FIELD REPORT – LYNNWOOD RECREATION CENTER – FIELD REPORT

REPORT #07

Job No. 10-100622B1

Location(s) of Work: Natatorium roof, HVAC Replacement.

Overview of the separator curb at the south end of the Natatorium Roof taken facing south.

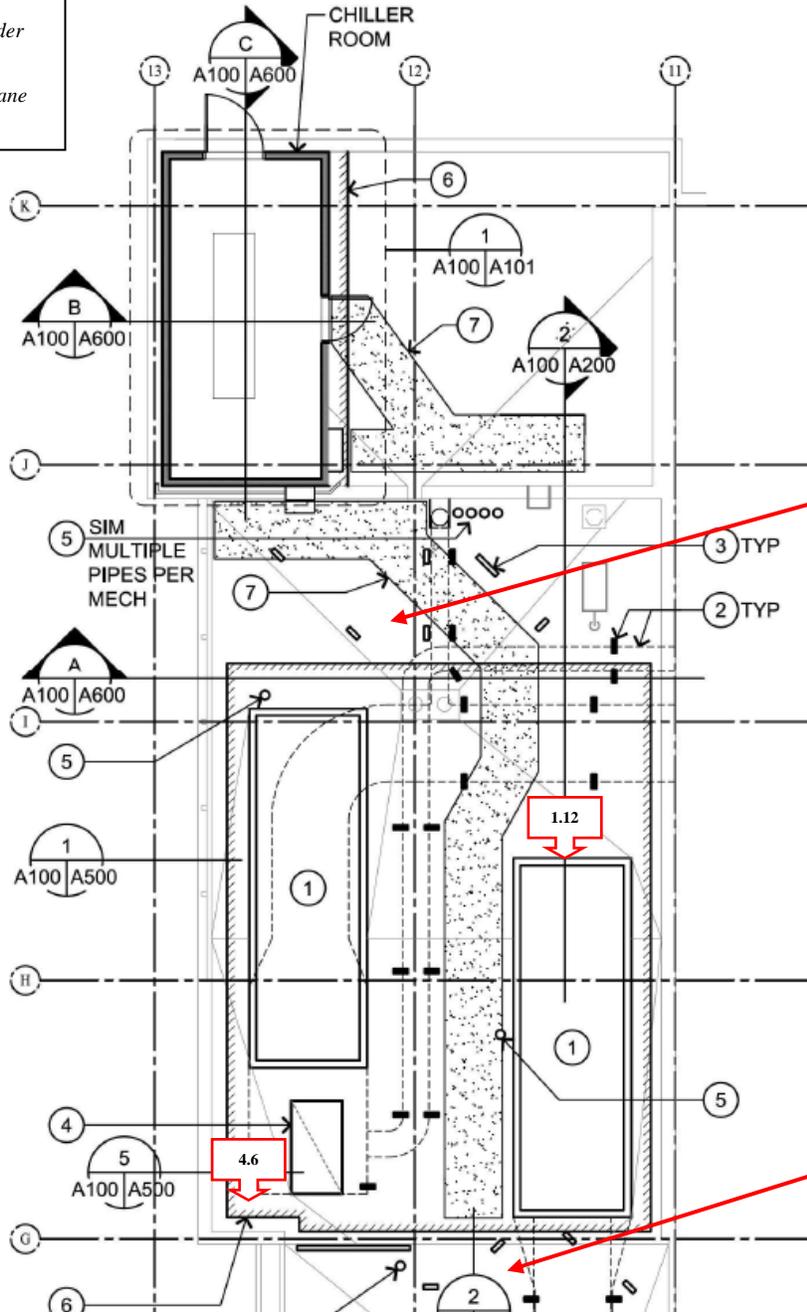
- 2.4 Per Wetherholt recommendation, the existence of a vapor retarder layer should be verified at the adjacent roof located south of the Natatorium Roof. If the adjacent roof was installed without a vapor barrier there is a possibility that water vapor may transfer over into the new roof assembly and damage the components. Per conversation with Anton Woody (GC, Holmberg) this is out of the scope of his contract but the construction team is aware of this issue.
- Update FR#04 – 09/19/2013: Item is unresolved
- Update FR#05 – 09/25/2013: Item is unresolved. No work is performed to open up this roof area yet.
- Update FR#06 – 09/26/2013: Item is unresolved.
- Update FR#07 – 09/27/2013: Item is unresolved.**
